Access Compliance Report

Public Rights-of-Way

Intersection ID: 17062	Main Street: IDLEWILD_RD	Cross Street: MONROE_RD	Location: NW
ADA ID: FDD0030EFCC6	Ramp Type: MedianPerp	Initial Pass/Fail: Fail	Overall Compliance: No
Severity Score: 13.75			
Codes/Mitigation Info/Possible Solution		Field Measurements/Component Compliance

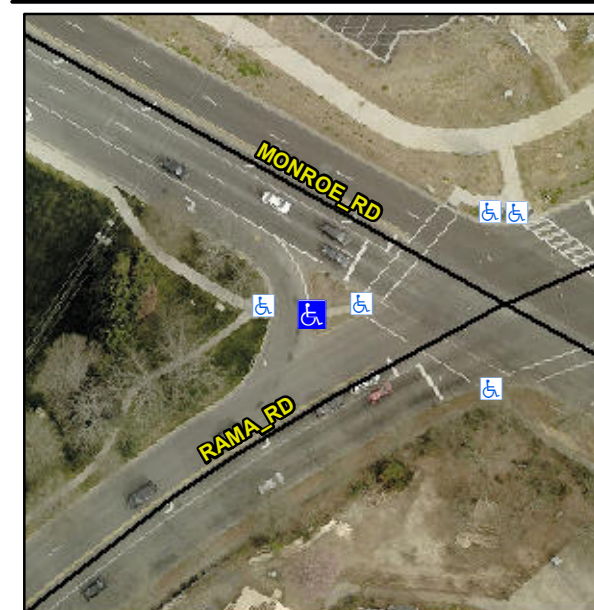
Not Found, R304.2.2, R304.5.3

Compliance	Description	Data	Compliance	Description	Data
N/A	Ramp Length (in)	56.0	No	Ramp Slope (%)	11.9
Yes	Ramp Width (in)	48.0	No	Ramp XSlope (%)	2.2
N/A	Flare Type LT	N/A	N/A	Flare Type RT	N/A
N/A	Flare Slope LT (%)	N/A	N/A	Flare Slope RT (%)	N/A
N/A	Flare Traversable LT?	N/A	N/A	Flare Traversable RT?	N/A
N/A	Landing Length (in)	N/A	N/A	DWS Provided?	N/A
N/A	Landing Width (in)	N/A	N/A	DWS Contrast?	N/A
N/A	Landing Slope (%)	N/A	N/A	DWS Length (in)	N/A
N/A	Landing X Slope (%)	N/A	N/A	DWS Full Width?	N/A
N/A	Landing Curb? (Y/N)	N/A	N/A	DWS Offset (in)	N/A
N/A	Shared Landing?	N/A			
N/A	Gutter Ponding?	N/A	N/A	Gutter Slope (%)	N/A
N/A	Gutter Lip Ht (in)	N/A	N/A	Gutter X Slope (%)	N/A
N/A	Painted X Walk1?	Yes	N/A	Painted X Walk2?	N/A
	X Walk 1 Direction	To NW		X Walk 2 Direction	N/A
N/A	X Walk 1 Width (in)	112.0	N/A	X Walk 2 Width (in)	N/A
	X Walk 1 Slope (%)	1.3		X Walk 2 Slope (%)	N/A
	X Walk 1 X Slope (%)	3.8		X Walk 2 X Slope (%)	N/A

Remove & Replace Entire Ramp.
